Week 11

Keel Bone Chicken Project

03/16/26

Information from DL-Engineering

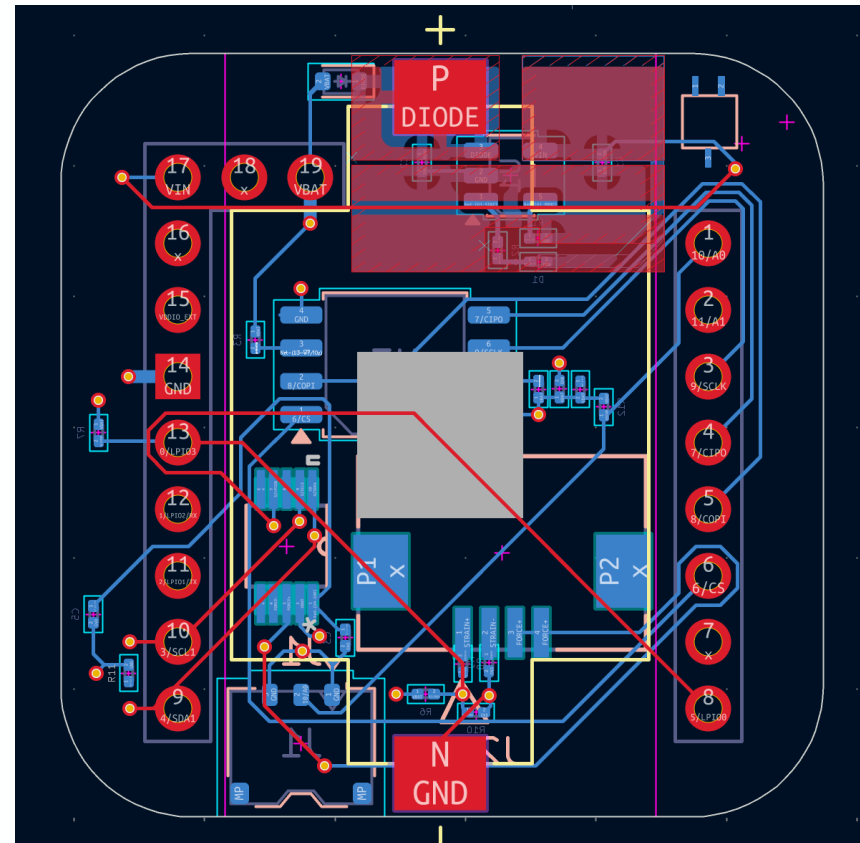
- Lead Time: ~4 weeks for PCB designs
- ~\$150-200 for total manufacturing costs
- Sizing requests
 - Increase size of resistors to maximum possible size to increase surface adhesion
 - All larger components should be placed on the same size to improve stability

Version of PCB to send to DL-Engineering finalized

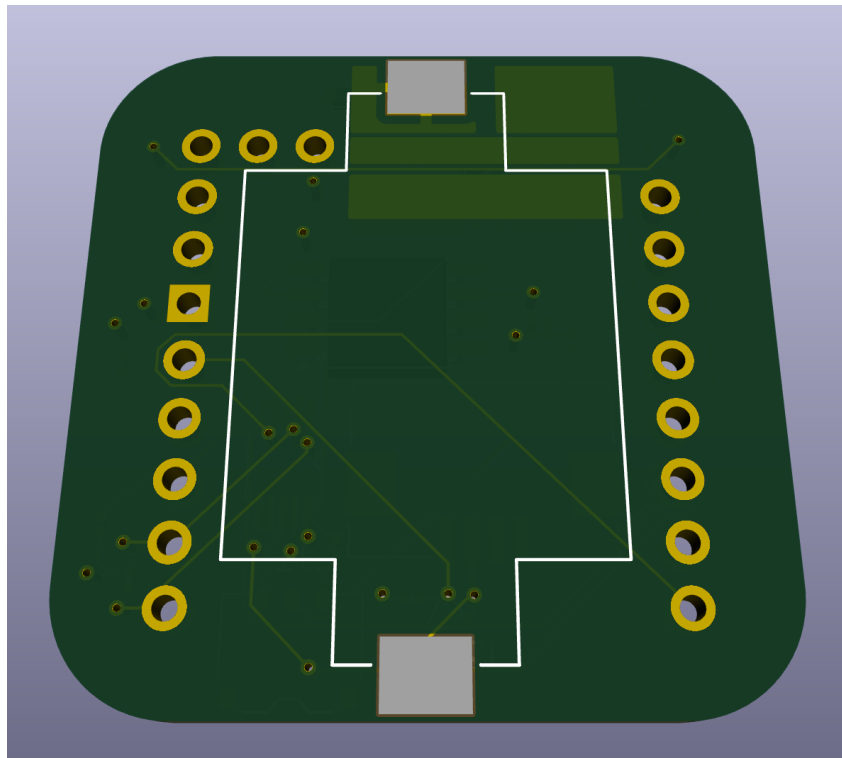
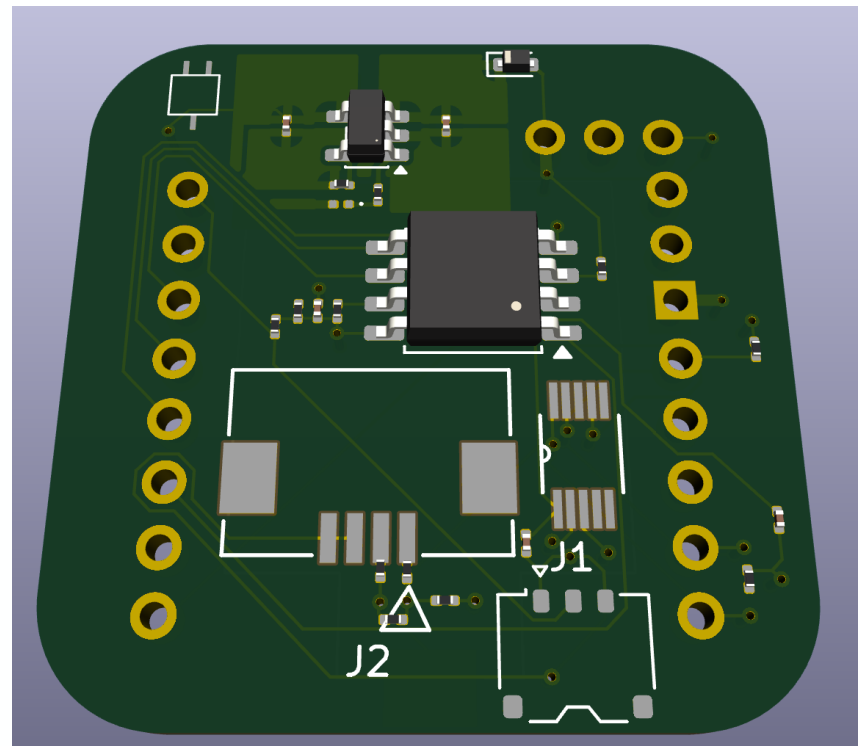
- PCB Routing and Layout complete
- 4 Layer Board
 - Front
 - Battery Voltage (VBAT)
 - Ground (GND)
 - Back
- Maintained same components and kept same area as last week
